Duquesne Light

Reference: Beaver Valley Power Station, Unit No. 1
Docket No. 50-334, License No. DPR-66
Post Implementation Review of NUREG-0737, Items
II.F.1.4, II.F.1.5 and II.F.1.6

Response to NRC Letter
dated December 16, 1982

FIGURE 1

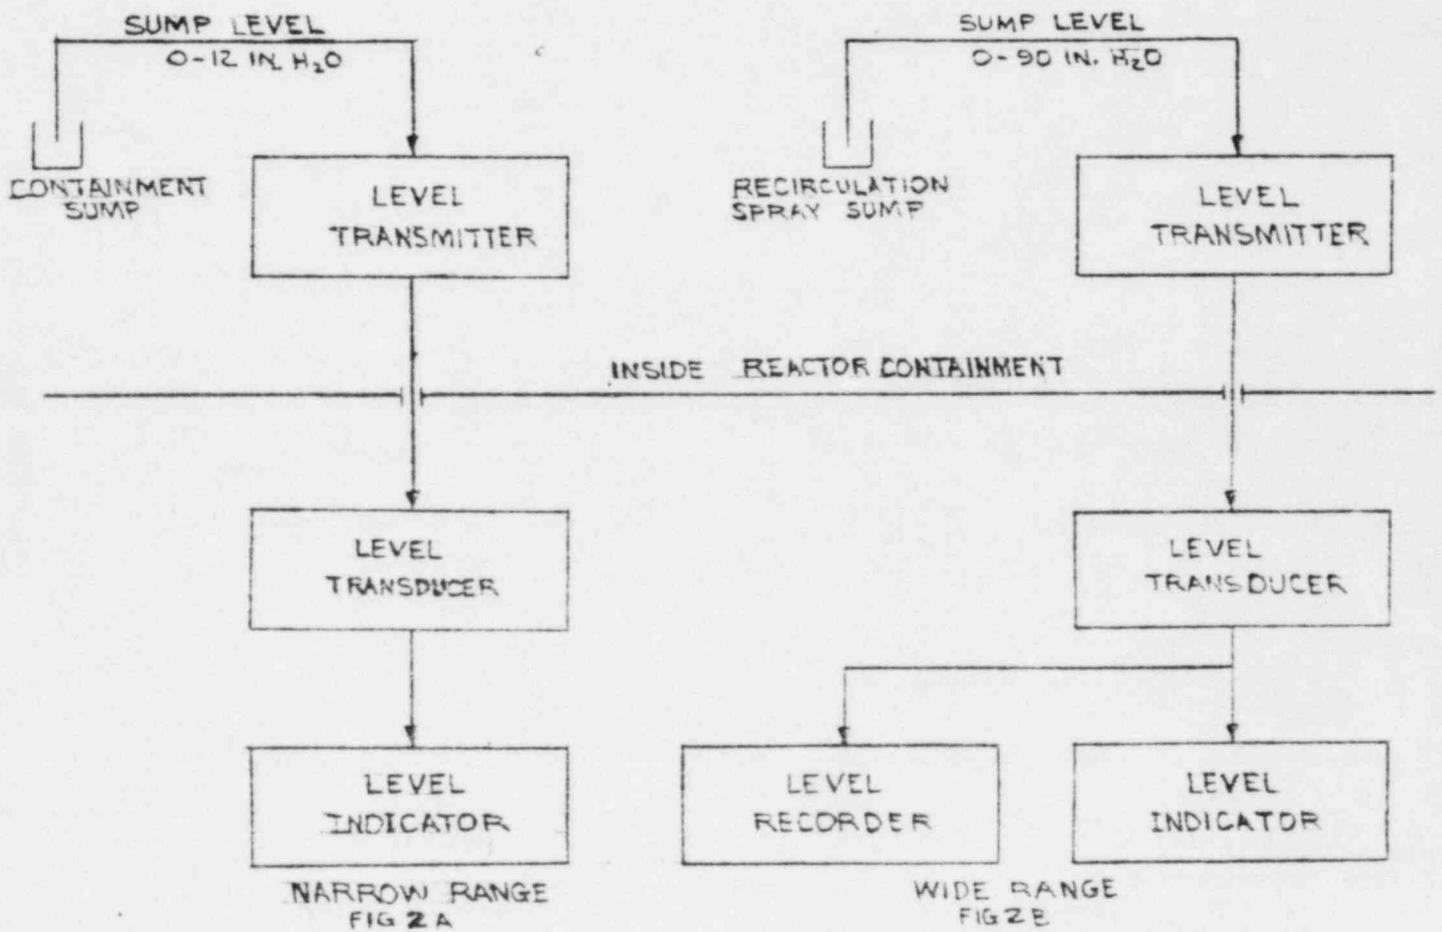
- 2a. Provide a block diagram of the configuration of modules that make up your PMS. Provide an explanation of any details in the block diagram that might be necessary for an understanding of your PMS accuracy and time response.

Refer to Figure 1 for a block diagram and equipment location relative to containment.

Range:	0-200 psia
Accuracy:	$\pm 0.25\%$ (Full Scale)
Temperature Effect:	$\pm 3.75\%$ per 100° (65° - 116° F)
Stability:	$\pm 0.375\%$ in six months

PMS Indication:	$\pm 0.897\%$ (Full Scale)
PMS Recording:	$\pm 0.763\%$ (Full Scale)

FIGURE 2

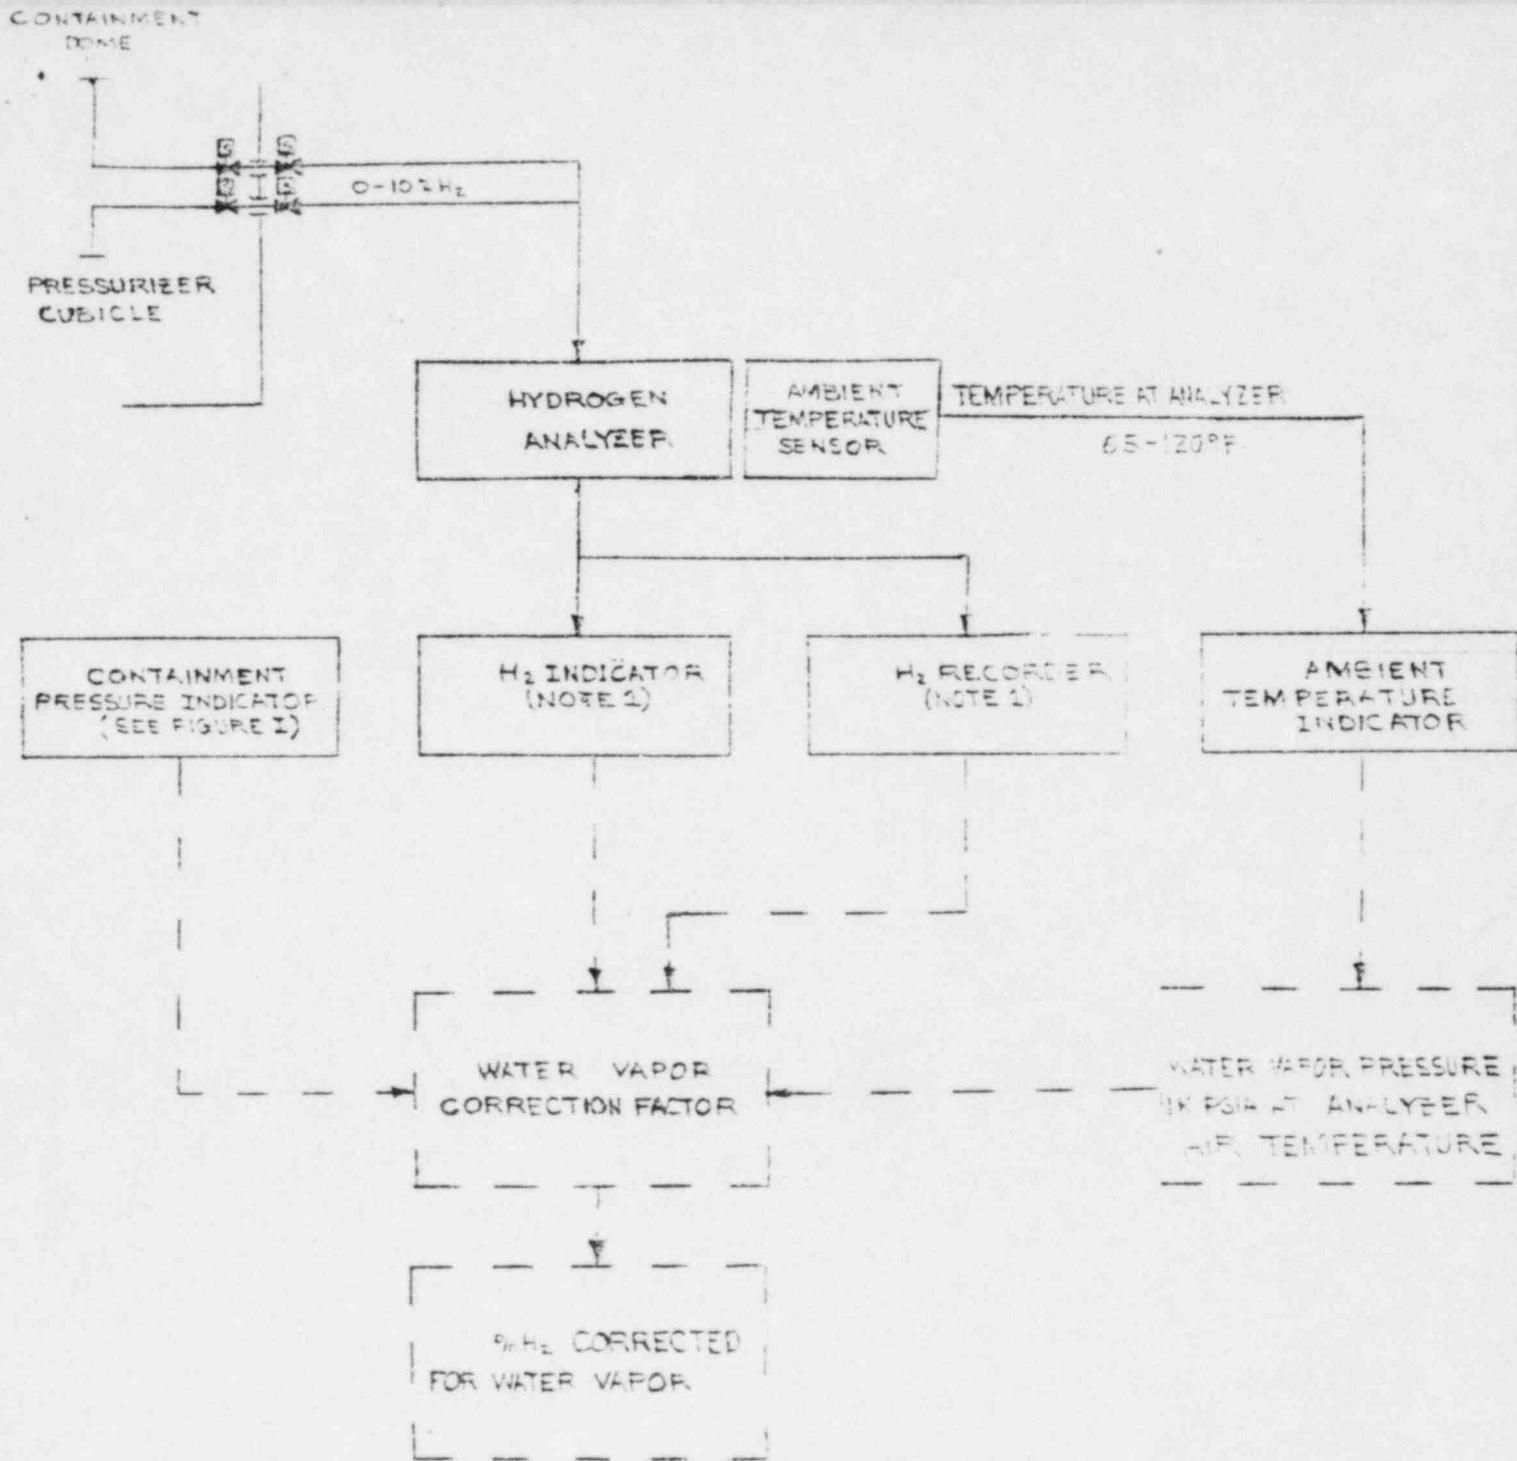
- 3a. Provide a block diagram of the configuration of modules that make up your WLMS. Provide an explanation of any details in the block diagram that might be necessary for an understanding of your WLMS accuracy.

Refer to Figure 2 for a block diagram and for equipment location relative to containment.

Range: 3-93 inches
Accuracy: $\pm 0.56\%$ at any point within range

WLMS Wide Range Indication:	± 0.85% (Full Scale)
WLMS Wide Range Recording:	± 0.71% (Full Scale)
WLMS Narrow Range Indication:	± 1.62% (Full Scale)
